CONSTRUCTION DOCUMENTS FOR:
HAVEN VALLEY
 (LETA DR.) BRADLEY RD/ALTURAS DR.
 SECURITY, EL PASO COUNTY, COLORADO

v1_Construction Drawings.pdf Markup Summary 10-19-2023

**WATER
 CABLE LANE
 PLAN & PROFILE**

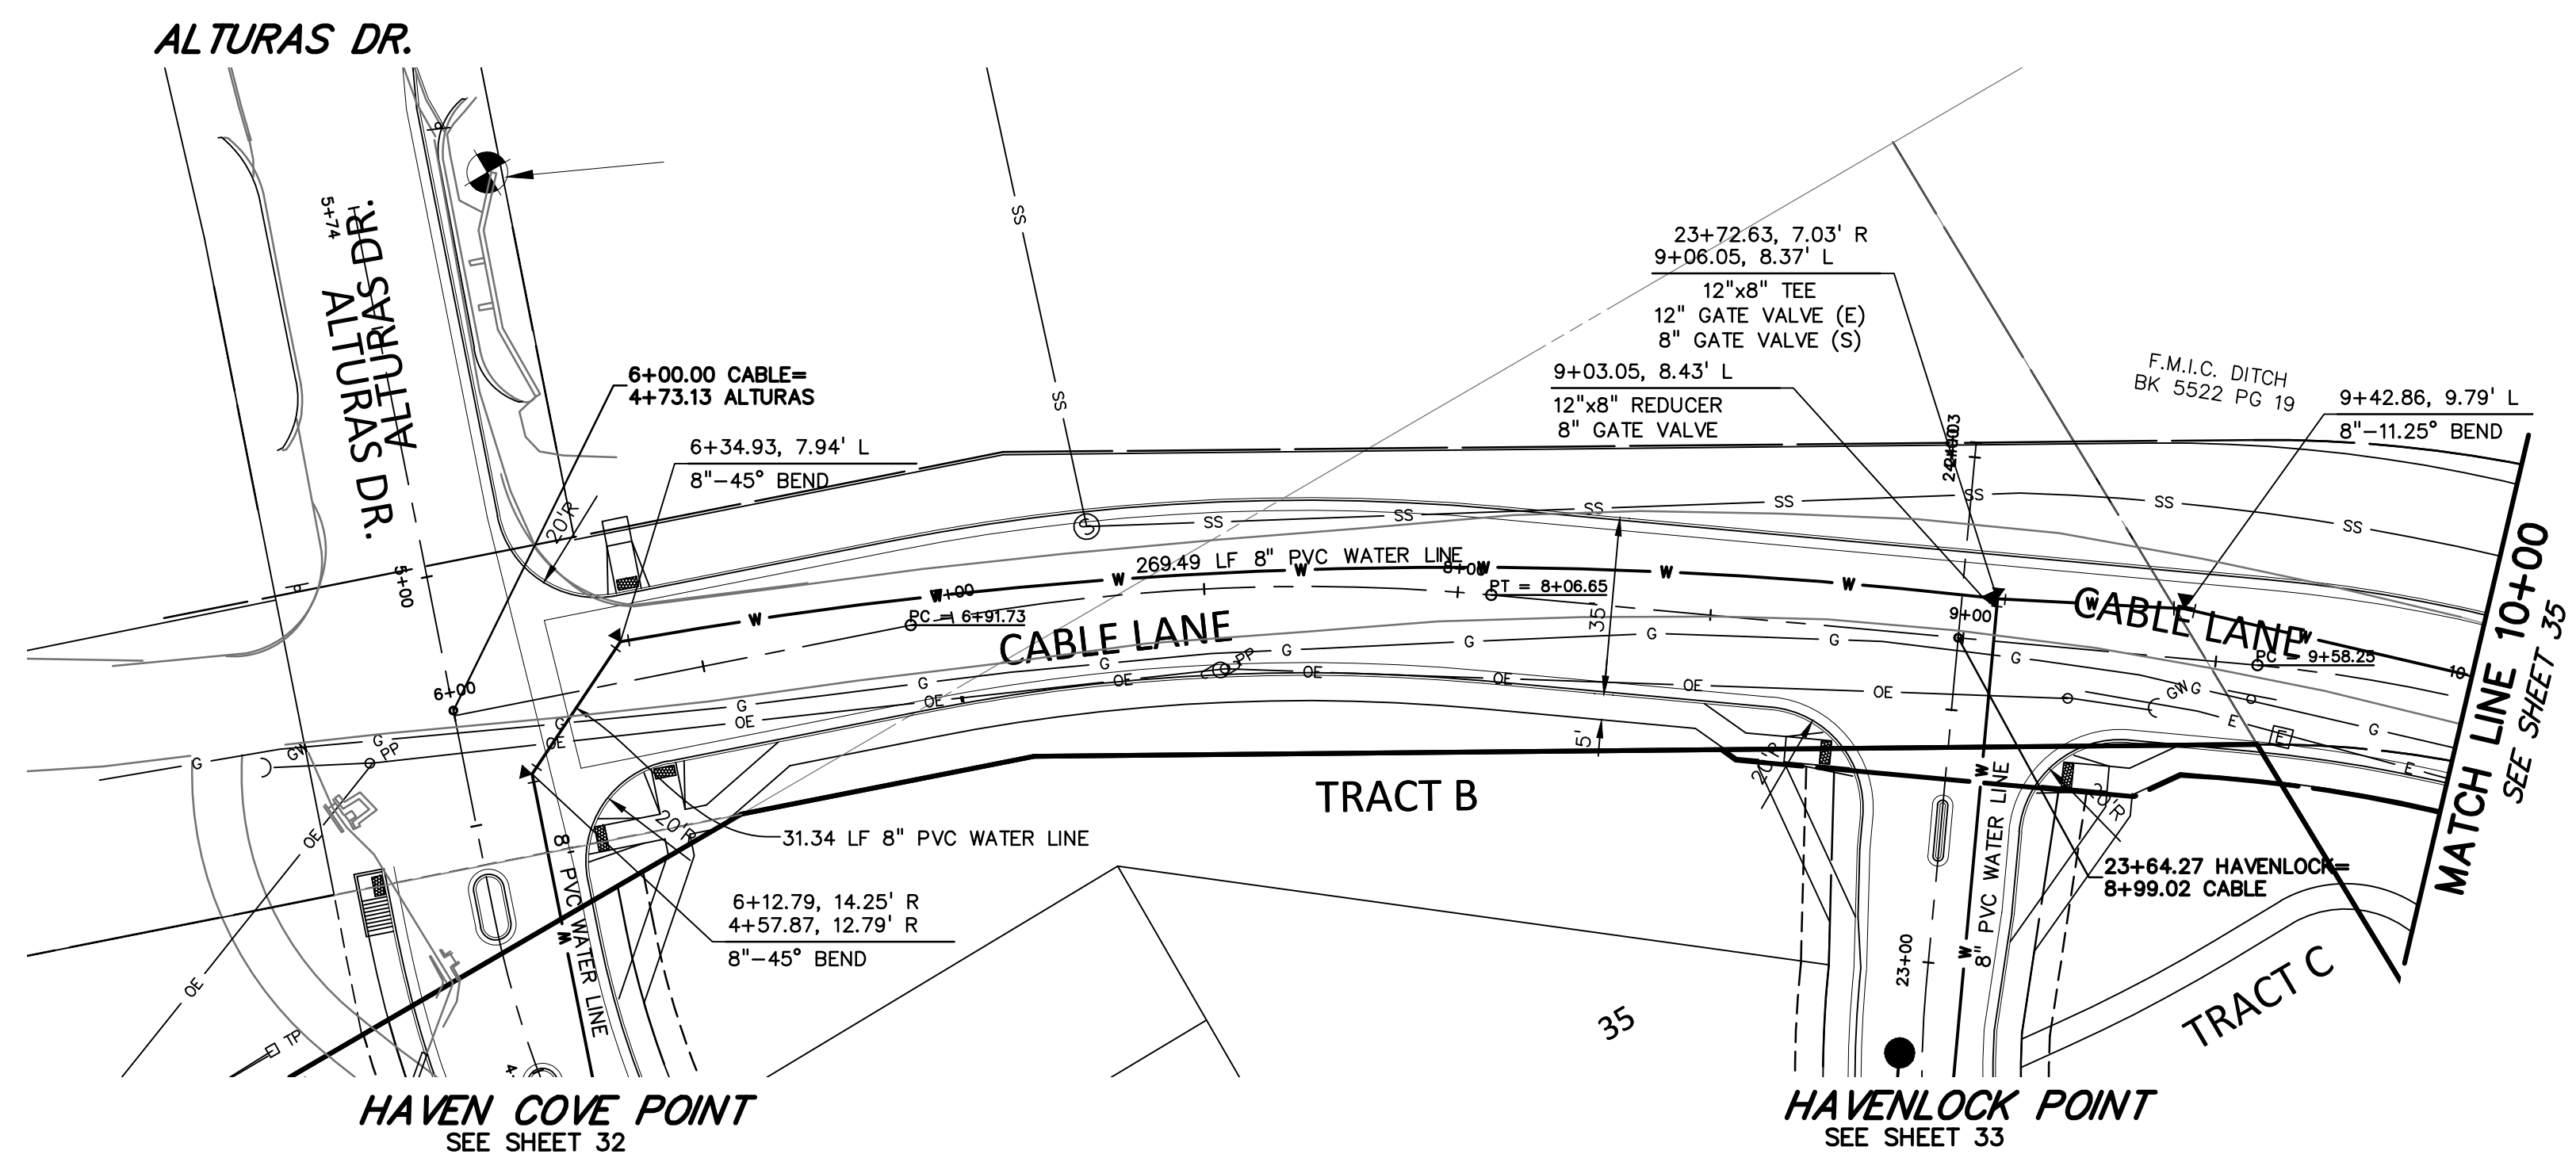
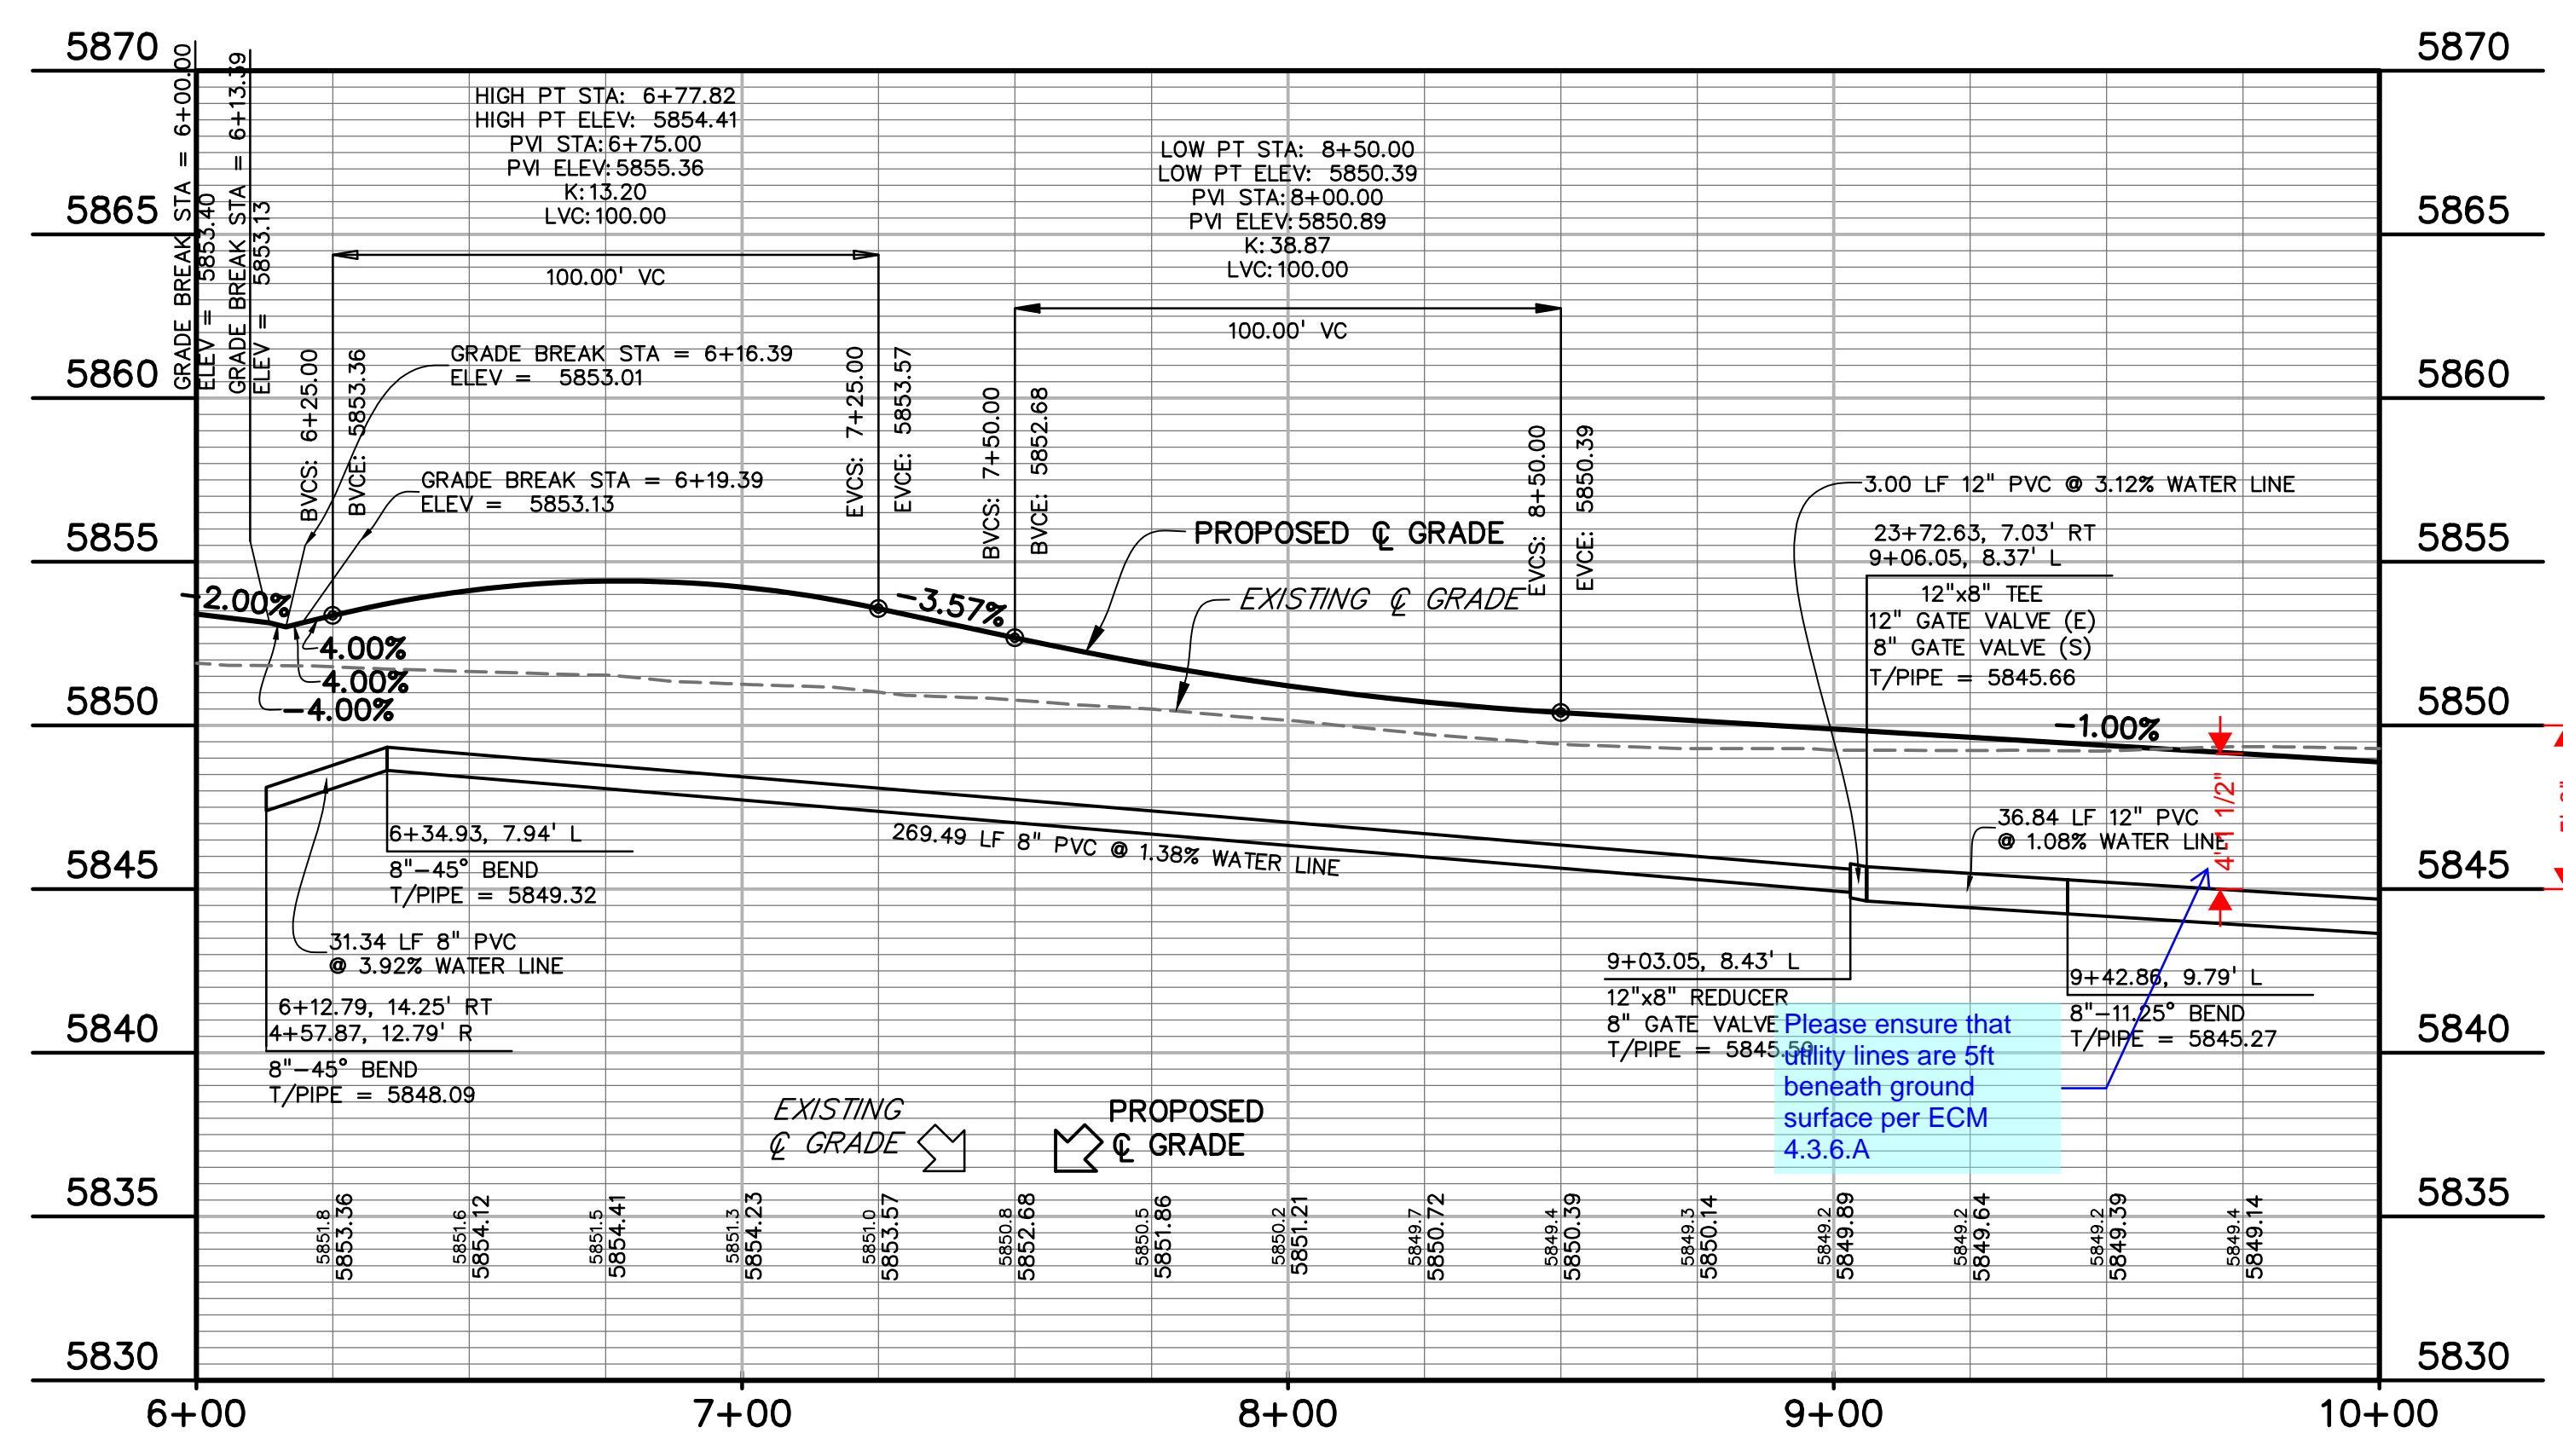
Please ensure that
 utility lines are 5ft
 beneath ground
 surface per ECM
 4.3.6.A

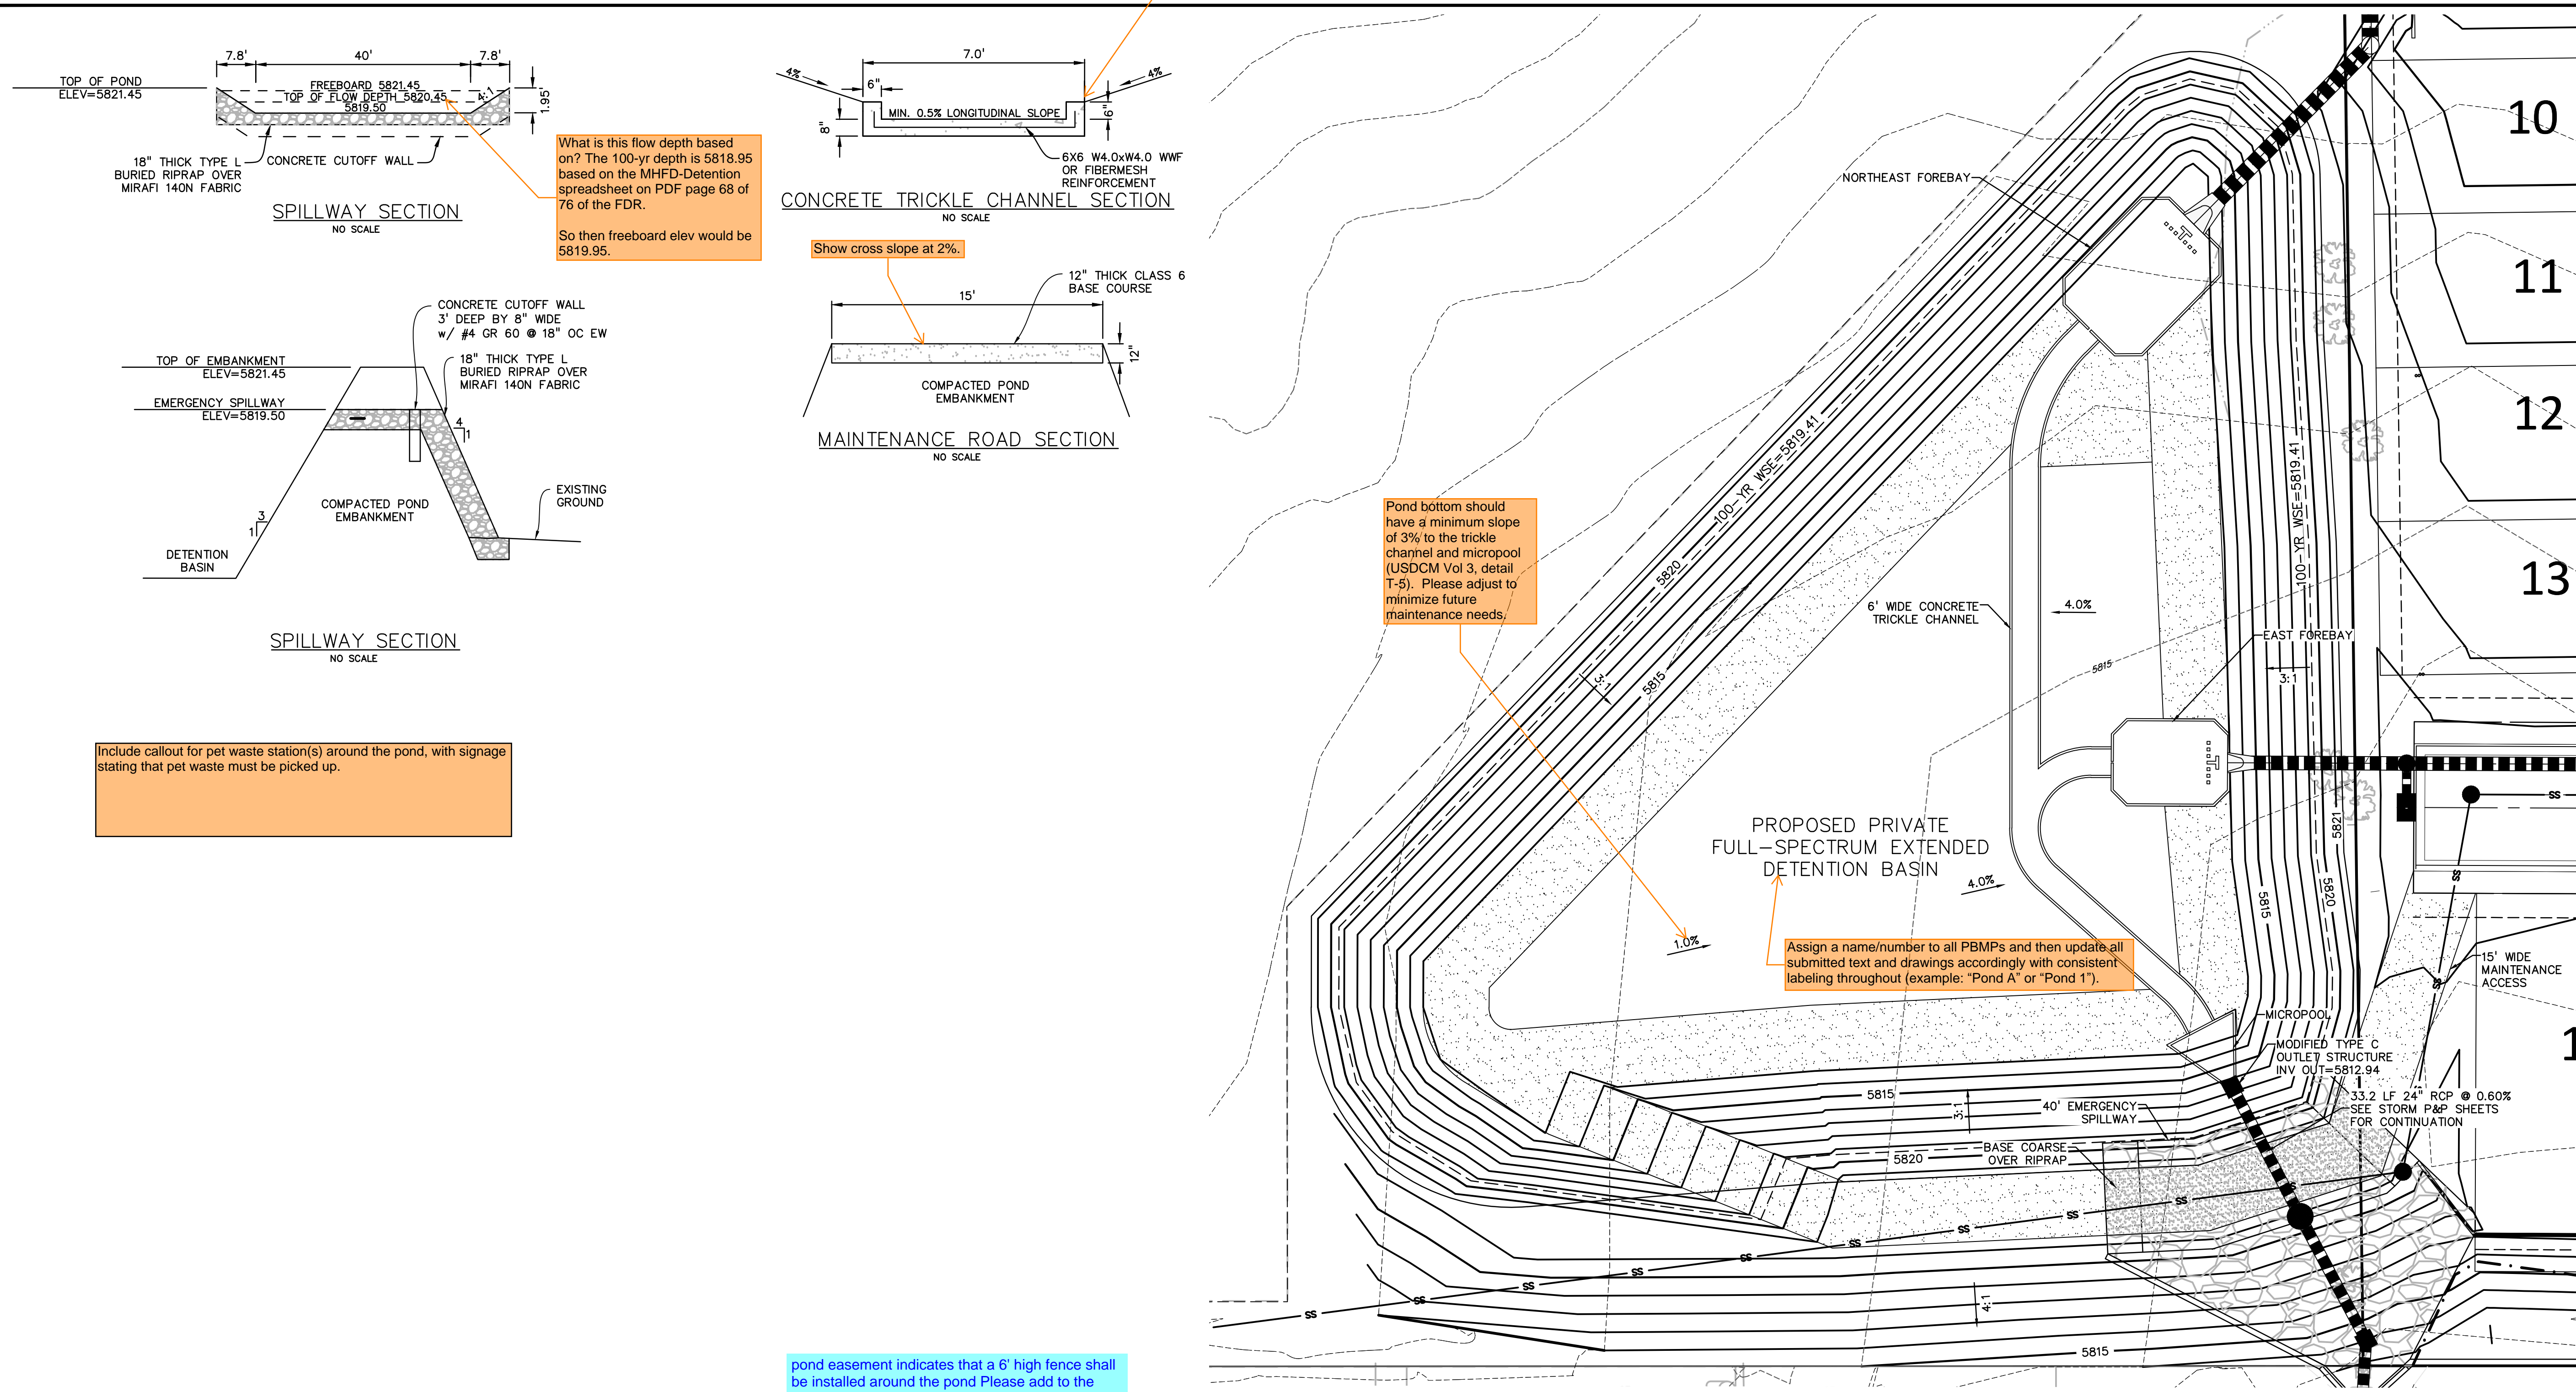
Pond bottom should have a minimum slope of 3% to the trickle channel and micropool (USDCM Vol 3, detail T-5). Please adjust to minimize future maintenance needs.

pond easement indicates that a 6' high fence shall be installed around the pond Please add to the plans. See below
